To: Egan, Robert[egan.robert@epa.gov]; Greenwater, Anthony[greenwater.anthony@epa.gov]; Manville, Jennifer[manville.jennifer@epa.gov]; Dee.allen@ldftribe.com[Dee.allen@ldftribe.com]; Kamke, Sherry[Kamke.Sherry@epa.gov]; lwawronowicz@ldftribe.com[lwawronowicz@ldftribe.com]
From: KHanson@ldftribe.com
Sent: Wed 5/3/2017 6:53:33 PM
Subject: Source data answer from Bristol/S2C2- EPA-Tribe Tracking Matrix 2B Tribal comments submitted and incorporated- Model #3 Groundwater comments
[image003.wmz](#)
[image005.wmz](#)
[image013.wmz](#)
[image020.wmz](#)

Thank you for the report entitled Supplemental Data Analysis and Data Visualization for the Tower Standard Site dated March 20, 2017 provided to the Tribe on April 28, 2017. The Report includes the source data used, information on how the visualization was created, QA/QC information, and reference to applicable confidence bound factors. This report certainly expedites the review of the model files provided on April 3, 2017. I found the report useful to 4dm model review. Because of the pressing monitoring well placement discussions, two of the six 4dm files were prioritized for review.

Data Visualization #3:

Groundwater Model Visualization Based Groundwater on Sampling Data

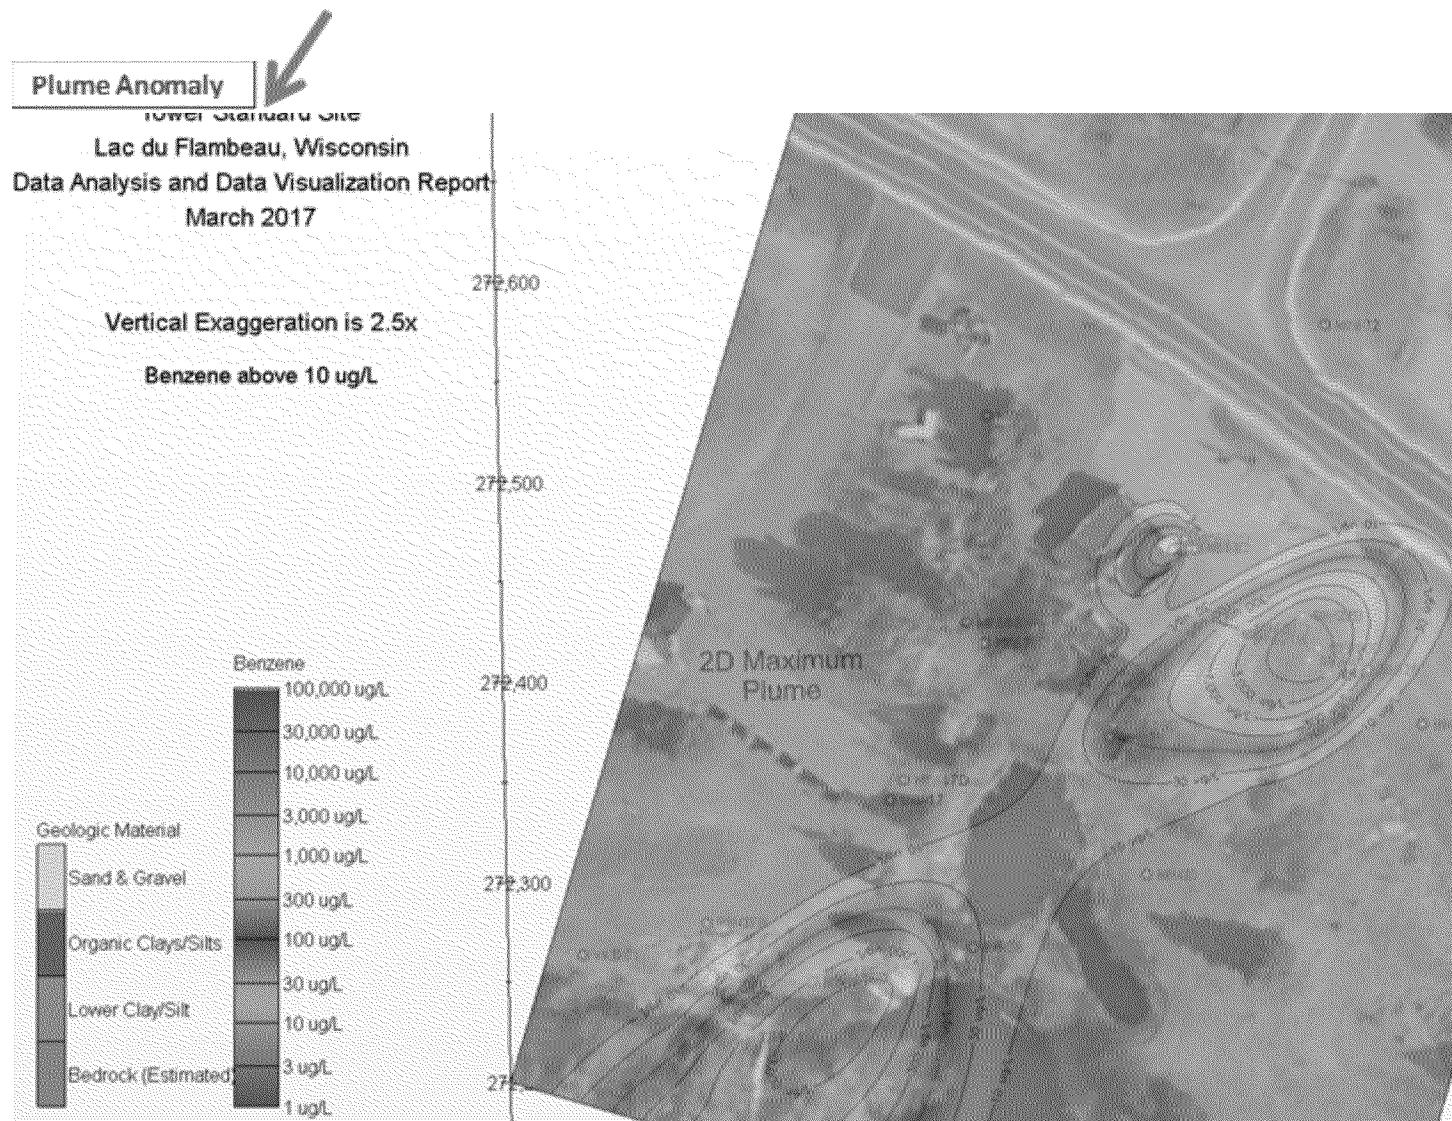
Data Errors: Monitoring Well Construction details and elevation screens are in error in the source data. The actual screened interval elevations differ from well construction records for 11 monitoring wells.

Data Removed at Request of Client: In some visualization slides some data was removed at the request of the client. We are not comfortable removing BH17 data and sharing the files as agreed Conceptual Site Models.

Representation shows contamination further to the east than data supports and in the area of documented clean soil and groundwater. It appears that the model is skewed to the east and underrepresented to the west.

The plume represented in the two groundwater figures do not agree.

Plume Anomaly- Well Construction Data Errors

The Anomaly shows part of the tank basin, pump islands, and piping are all outside of the plume. It appears that the anomaly could be due to data errors. Monitoring well construction details including screened intervals listed in the Data Visualization Report differ from well log. These data errors occur for: MW-1, MW-2, MW-3, MW-16, MW-17, Mw-18, MW 18D, MW-19, MW21, MW22, MW-22-D. Because of the 3 dimensional representation, inaccurate depths in one dataset, compared to accurate depths in another dataset could be misrepresenting the plume.

Groundwater contamination in the plume anomaly appears to be a function of depth. Direct sensing in the area shows a distinct change in estimated hydraulic conductivity, and HPT Pressure at a depth of 14.5 feet suggesting more transmissive soils. Contaminated groundwater and significantly contaminated soils were identified in BH17 located near the corner of the building. A groundwater well near this location is screened from 4.4 -14.4 feet and 11/15/2015 sampling results provide 238 ug/l total VOCs. The adjacent BH17 includes a temporary well installed from 10-15 feet and the sampling results provide 24,867 ug/l. It is clear that contaminated groundwater is encountered between 14.4 and 15 feet (and likely deeper). The problem is the source data sees both data sources at the same depth (15 feet) when actual depth difference is present. If monitoring well depth were properly entered, the visualization would likely extend the plume beneath the anomaly area.

HRSC_CSM_Direct Sensing.4dm - slide 9

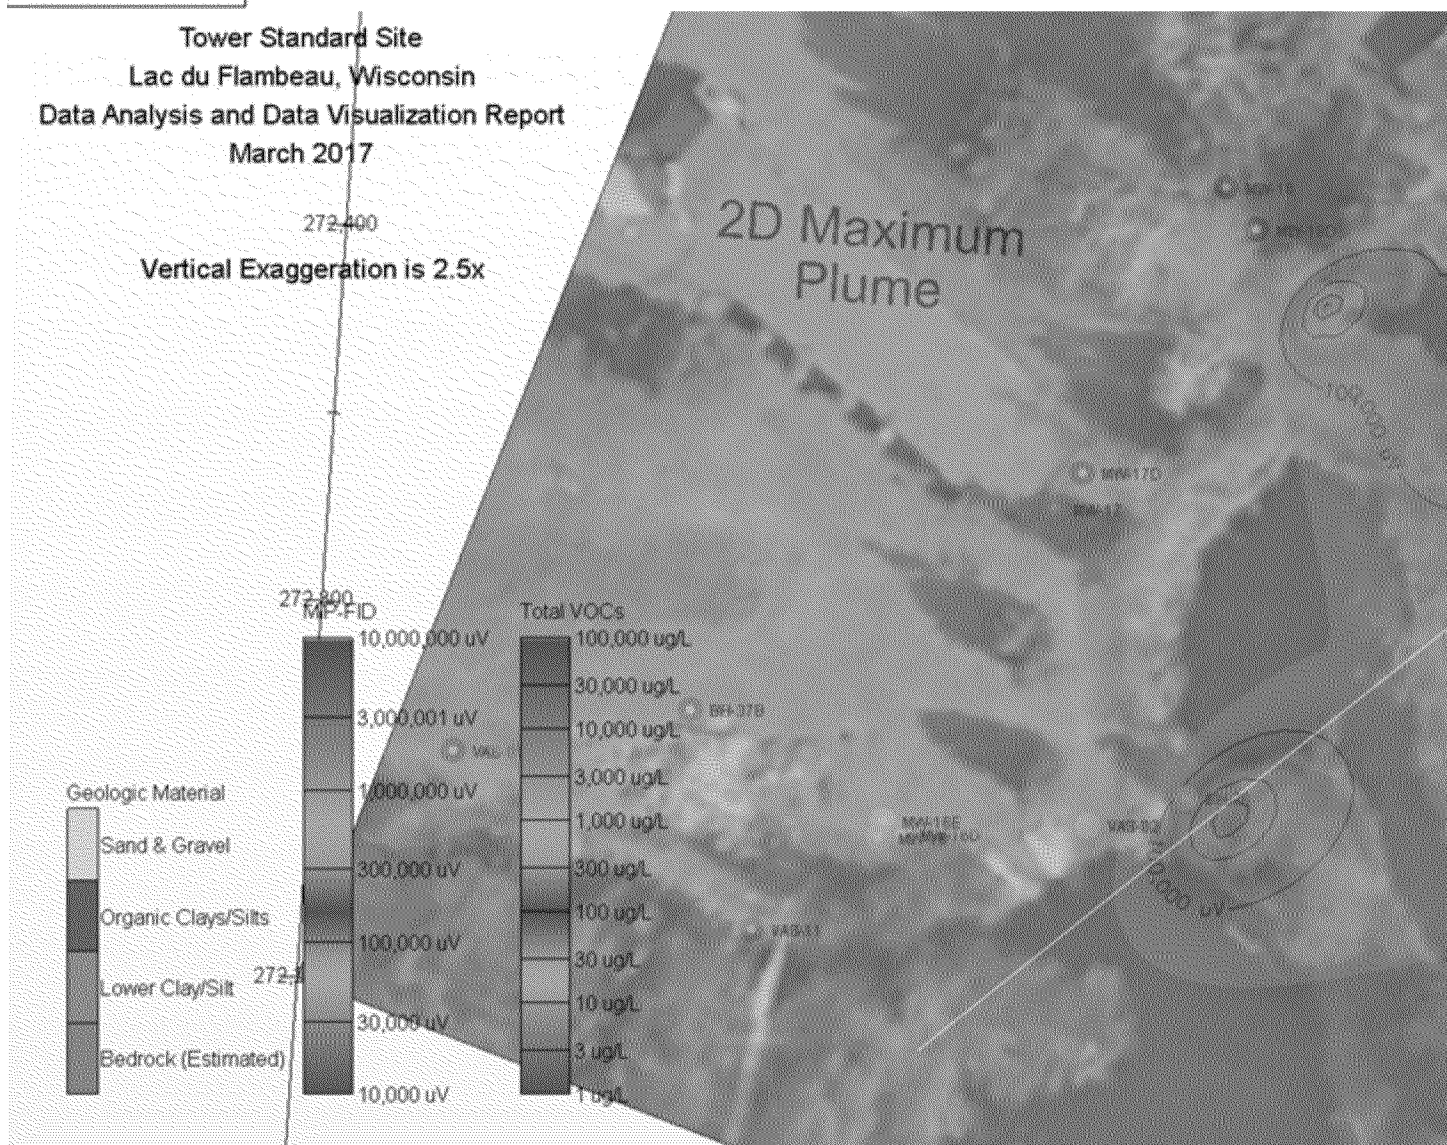
West Control Points underrepresents plume to the west :

The represented plume direct sensing plume appears to underrepresent the plume to the west. This may be attributed the data addition of control points at MW17. The additional data points for MW17 include 39 feet of MIP-PID response of 1,000 uV. The Groundwater data utilized in this model was collected by the State Contractor REI on 11/17/2015 utilizing a vacuum peristaltic pump. It should be noted that this method is not recommended and may underrepresent VOC's by volatilizing under vacuum. The total VOCs from the 11/18/2015

sampling event was 7.38. The MIP-FID equivalent to the low level concentrations would be closer to 30,000 uV. However the control point used in the representation is 1,000 uv. Underrepresenting the control point may be skewing the visualization to the east.
